GEORGETOWN-SCOTT COUNTY PLANNING COMMISSION

March 14, 2019

G & F FARMS PROPERTY
Staff Report to the Georgetown-Scott County Planning Commission
March 14, 2019

**HOGHEAD TRAILER SALES
PRELIMINARY DEVELOPMENT PLAN**

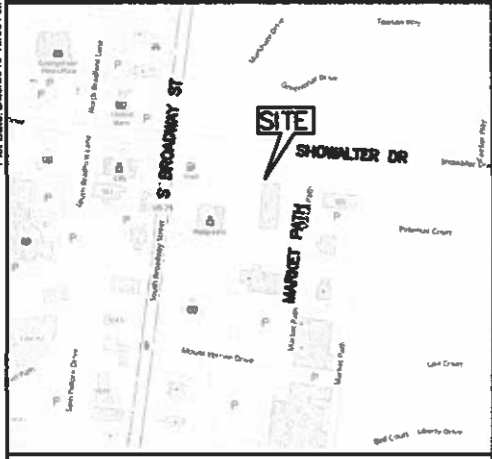
Preliminary Development Plan Review:
The Preliminary Development Plan does not involve any proposed buildings or other structures that would be subject to setback or building height requirements.

The Applicant is requesting the Planning Commission allow the use of gravel on the Project Site. Historically, gravel has not been allowed for use in commercial developments in Georgetown. If the Planning Commission grants approval for this Project Site to use gravel for the display and sale of trailers, staff recommends adding conditions to prevent the use of the gravel area for vehicle parking, vehicle sales, or the display or sale of other items without first consulting with Planning Commission staff. Because the gravel area is proposed only for the display and sale of trailers and offers some stormwater advantages as a pervious surface, staff is not opposed to the use of gravel in this instance with conditions. Additionally, if the use of gravel is approved, staff may file a Certificate of Land Use Restriction at the Scott County Courthouse to inform future property owners about the limited uses of this gravel area.

The Applicant is proposing to preserve an existing tree in the center of the proposed gravel area. For the 0.77-acre site, a total canopy coverage of 7,714 square feet is required (23%). The Applicant is requesting a waiver to allow trees needed to meet the canopy requirements to be planted on an adjoining property. Staff does not support this waiver for a couple of reasons:

1. The adjoining properties may one day be sold, and the trees removed by a new property owner.
2. If the adjoining property is redeveloped, the adjoining property may attempt to double count these trees to meet its landscaping requirements.
3. The tree canopy required for this Project Site would be better used along the boundary of the display area in conjunction with the existing plank fence. Trees could be spaced in a way that

Staff will be looking at the construction plans to see how the centrally located tree will be preserved. Best practices indicate that the area within the dripline should not be disturbed during construction to protect the critical root zone. Staff will look for the Applicant to exclude the critical root zone from the graveled area.

Staff recommends **approval** of the Preliminary Development Plan to construct a 7,150-square feet commercial building, with the waiver and conditions of approval listed below. Staff does not recommend approval of the requested waiver to place canopy trees on the adjoining properties.

1. All applicable requirements of the *Zoning Ordinance* and *Subdivision & Development Regulations*.
2. The Final Development Plan will need to comply with all stormwater management requirements.

8. The property owner shall consult with Planning Commission staff before the gravel area is used for the display and/or sale of any items other than trailers.

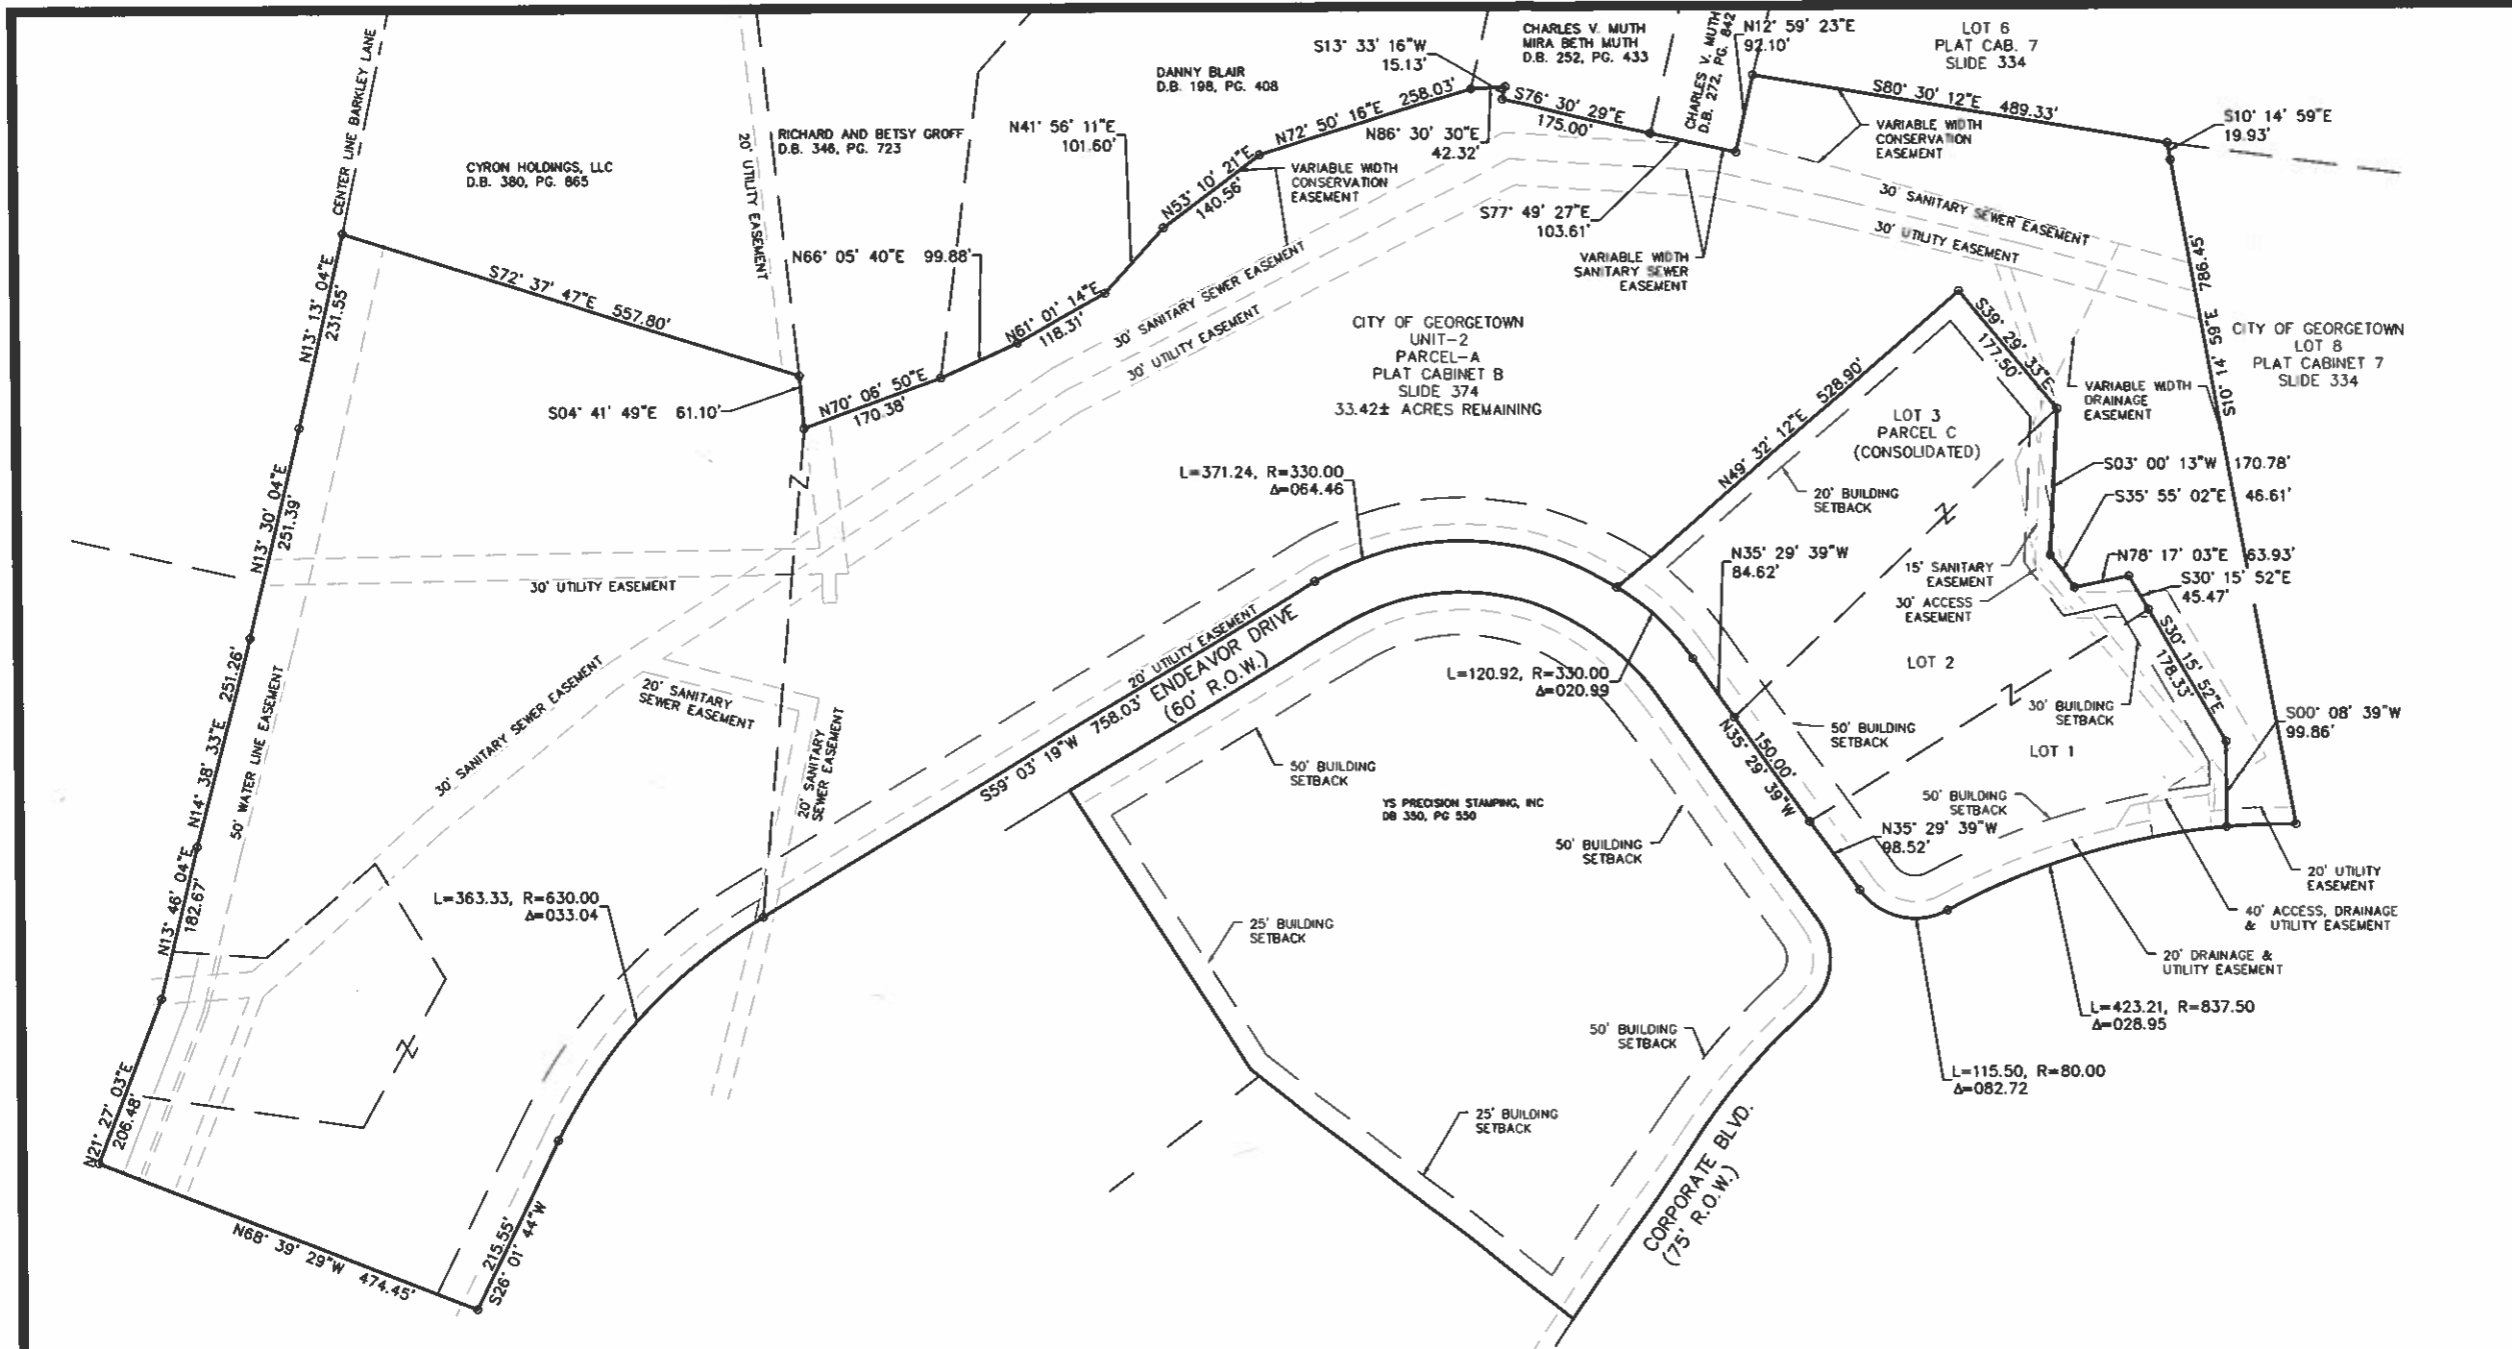
The Preliminary Development Plan shows a building that is approx. 120' x 290'. The building design and materials are to be reviewed and approved by the Business Park Authority. The Business Park Authority is scheduled to meet on March 8. They may recommend conditions by which the building design and materials will comply with the BP-1 standards. Complying with those recommendations will be made a condition of Planning Commission approval. The building as shown meets minimum setbacks and the maximum building area coverage of 40% of the lot. An amended Final Development Plan will be required for review and approval by Planning Commission staff at the time the future building expansion is proposed. At that time, review and approval of the building design will also be required by the Business Park Authority Board.

The applicant has provided a landscape plan and calculations for interior VUA areas and landscaping. The plan appears to be able to meet all the requirements of the Landscape and Land Use Buffers Ordinance. A specie-specific landscape plan will be required along with Final Development Plan submittal. No landscaping variances have been requested or are being recommended.

A Final Stormwater Management Plan must be submitted and approved by the Planning Commission Engineer prior to approval of the Final Development Plan.

The applicant is asking the Planning Commission for permission to do preliminary grading and site work prior to Final Development Plan approval in order to maintain their development schedule. Planning staff recommends that this request be granted with the condition that the Final Plat be recorded first and the property be under the ownership and control of the applicant. In addition, the erosion control, grading and stormwater management plans shall be reviewed and approved by the Planning Commission Engineer and a pre-construction meeting be held prior to start of work. No work shall begin on the building until Final Development Plan approval.

Staff recommends **Approval** of the Preliminary Subdivision Plat and Preliminary Development Plan for a 35,646 square foot building with an associated parking, loading and unloading area and a future approx. 35,000 SF building expansion area, with the following conditions of approval:

1. Final Subdivision (Consolidation) Plat shall be approved prior to Final Development Plan approval.
2. A Final Development Plan shall be submitted for review and approval of Planning Commission Staff for phase one construction. An amended Final Development Plan shall be submitted for review and approval of Planning Commission staff for any future phases, including the proposed future building expansion.
3. Any future phases including signage, building design and materials will require review and approval of the Business Park Authority Board.
4. No outdoor storage of materials is permitted. The applicant shall be responsible for providing landscaping which meets the minimum requirements of the Landscape and Land Use Buffer

5. A Final Stormwater Management Plan must be submitted and approved by the Planning Commission Engineer prior to approval of the Final Development Plan.

**PRELIMINARY DEVELOPMENT PLAN
PDP-1.0**

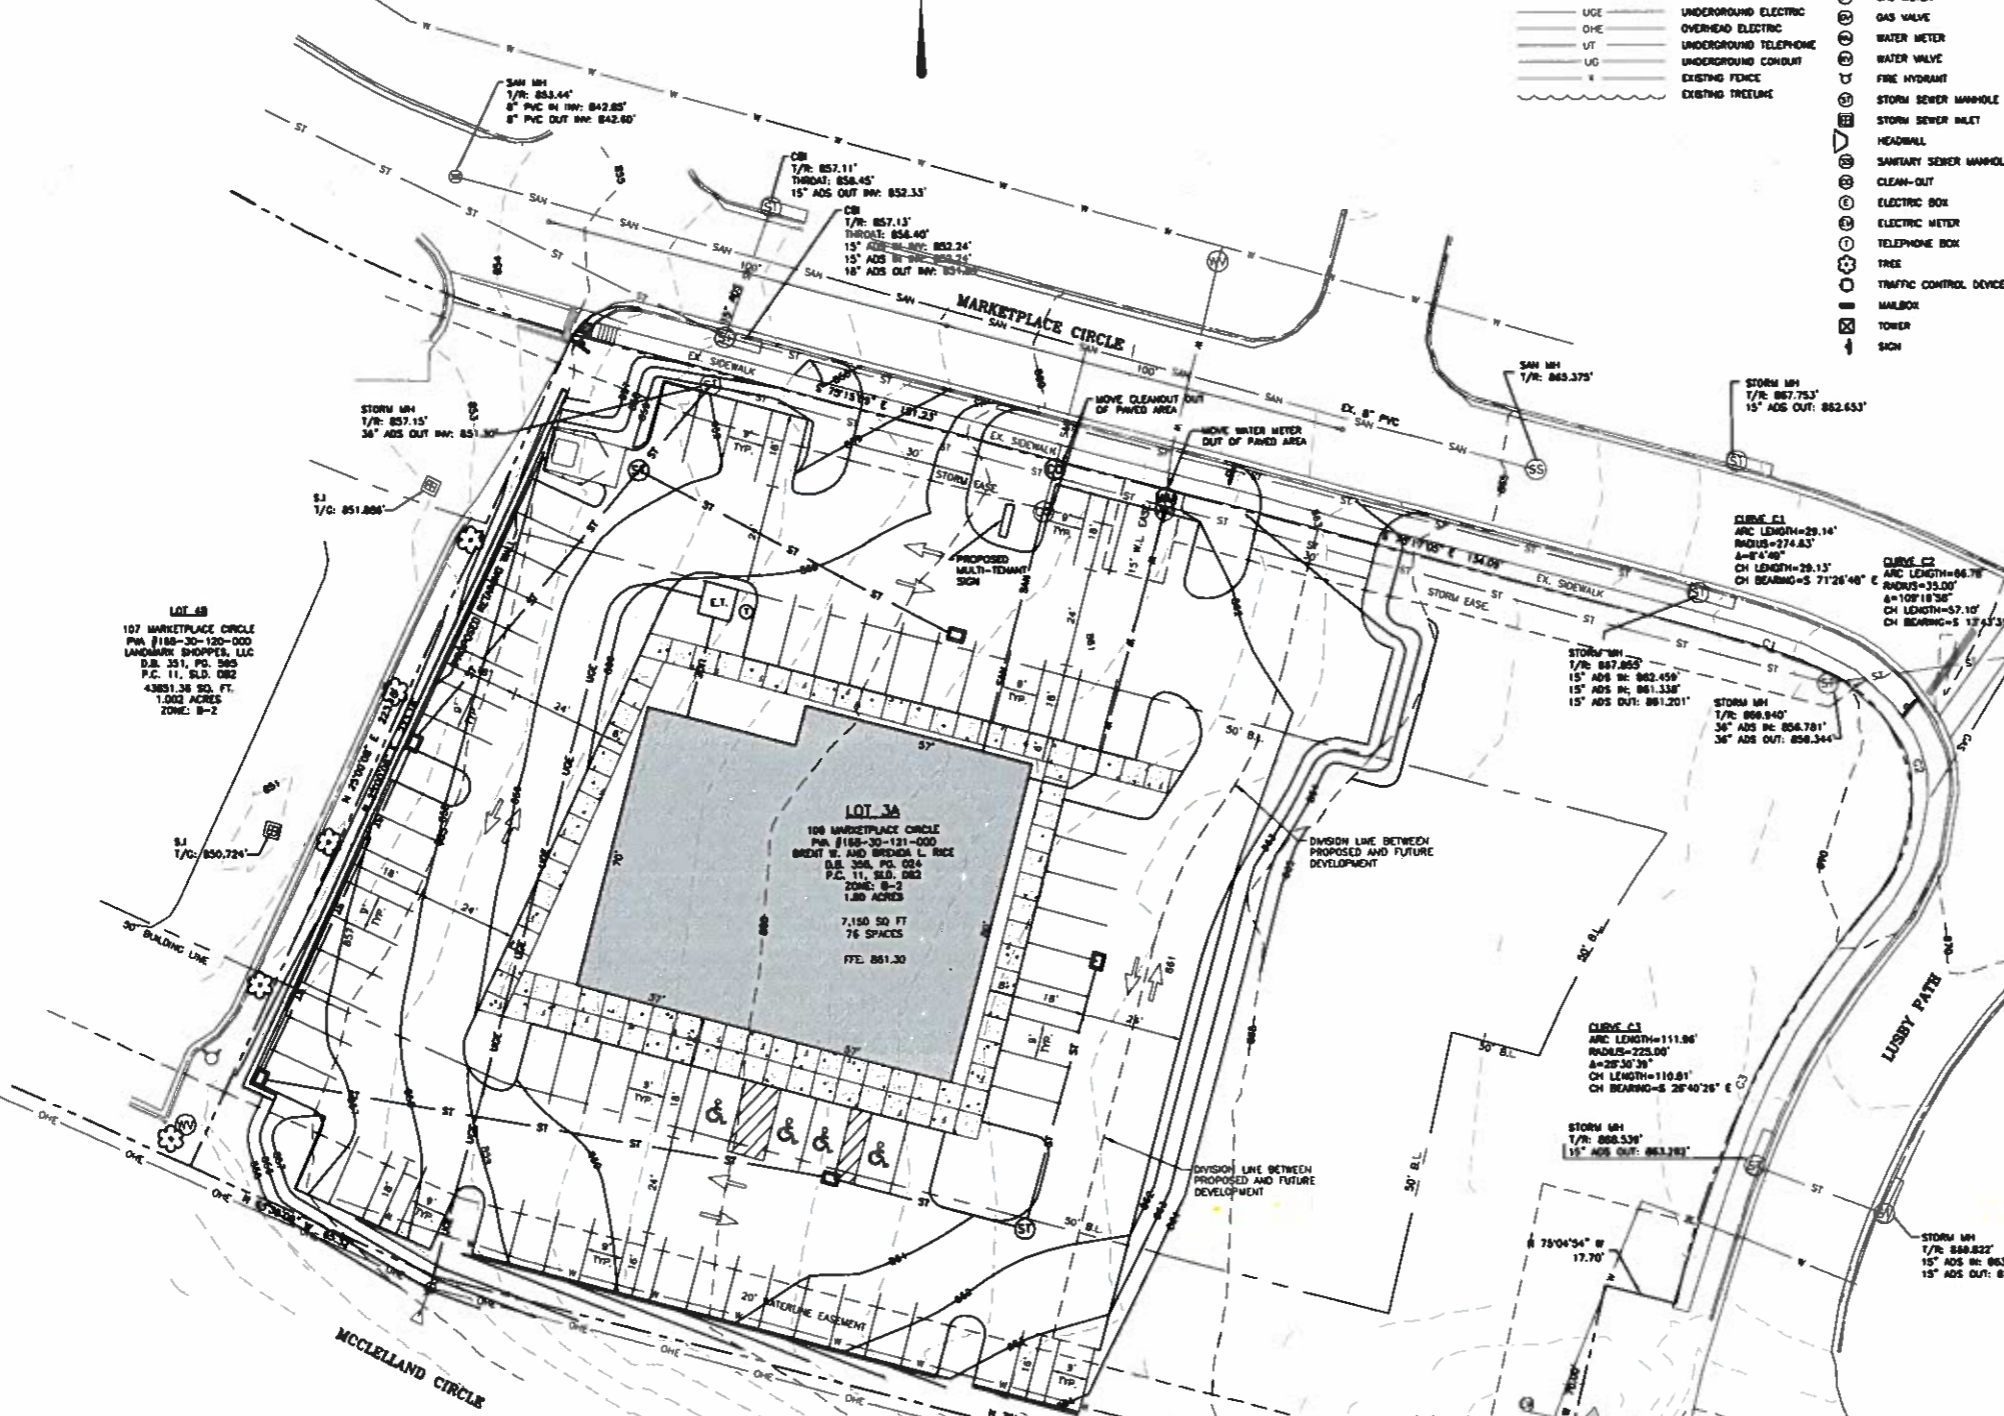
The proposed building locations and on the Preliminary Development Plan meet the required building setbacks. The Applicant is proposing 7,150 square feet of building area which is under the 50%

Parking Spaces: The *Subdivision and Development Regulations* require one (1) parking space per 150 square feet of commercial floor area, plus one (1) space for every truck operated by the business. The size of the proposed commercial building requires at least 48 parking spaces. The Preliminary Development Plan shows 75 parking spaces, which meets the requirements of the regulations.

The preliminary plan does not show the required property perimeter landscaping. The trees proposed along McClelland Circle are spaced too far apart, and the shrubs proposed do not meet the 6 feet height requirements. The neighboring property at 105-107 Marketplace Circle was granted a waiver to eliminate the required property perimeter landscaping along McClelland Circle. Waiving this landscaping buffer would not eliminate all buffering along the southern property line, because the Applicant would still need to provide VUA perimeter landscaping. Staff recommends granting a waiver to the property perimeter landscaping along McClelland Circle.

The Applicant has proposed 30,149-square feet of Vehicular Use Area on the Project Site, which requires 3,015-square feet of interior landscaped area. The Applicant has proposed 3,343-square feet of landscaped area, which meets the minimum requirements. The Applicant is required to have 12 interior trees and is showing 12. The preliminary development plan shows the appropriate interior landscaping for the VUA areas.

For the 1.80-acre site, a total canopy coverage of 18,818 square feet is required. With this application, the Applicant is only proposing to develop 1.1 acres, with the remaining 0.7 acres to be developed in the future. The Applicant will eventually need to provide appropriate canopy for the entire Project Site, but this development will need to provide appropriate canopy for the 1.1 acres being developed.

Staff recommends **approval** of the Preliminary Development Plan to construct a 7,150-square feet commercial building, with the following waiver and conditions of approval:

1. All applicable requirements of the *Zoning Ordinance* and *Subdivision & Development Regulations*.
2. The Final Development Plan will need to comply with all stormwater management requirements.
